SERVICE BULLETIN

M-1250

July 17, 2009

2009 FLTRSE3 BLADE WHEEL SAFETY RECALL 0140

Figure 1. Manufacturing Code Location

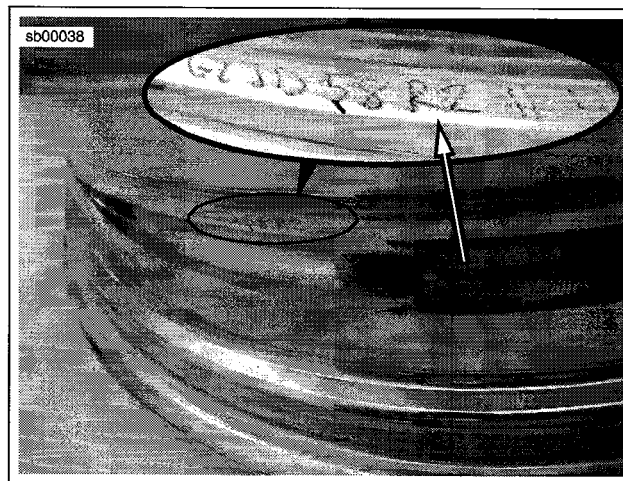
1. Confirm motorcycle is involved and that Campaign 0140 is open.
2. Remove the rear tire from the wheel. Refer to the service manual for specific steps for this procedure.
3. See Figure 1. The manufacturing code is a hand-engraved number located in the drop-center area of the wheel.
4. Obtain the manufacturing code. Inspect the code carefully. Wheels that are returned and found to not have the suspect codes will result in a charge-back to the dealership for dealer net on the wheel replacement kit.
5. If the wheel has a manufacturing code of R1 or R2, replace the wheel and file a warranty claim as outlined in the appropriate Replacement Credit Procedures that follow. If the manufacturing code is not R1 or R2, file a warranty claim as outlined in the appropriate Inspection Credit Procedures that follow.
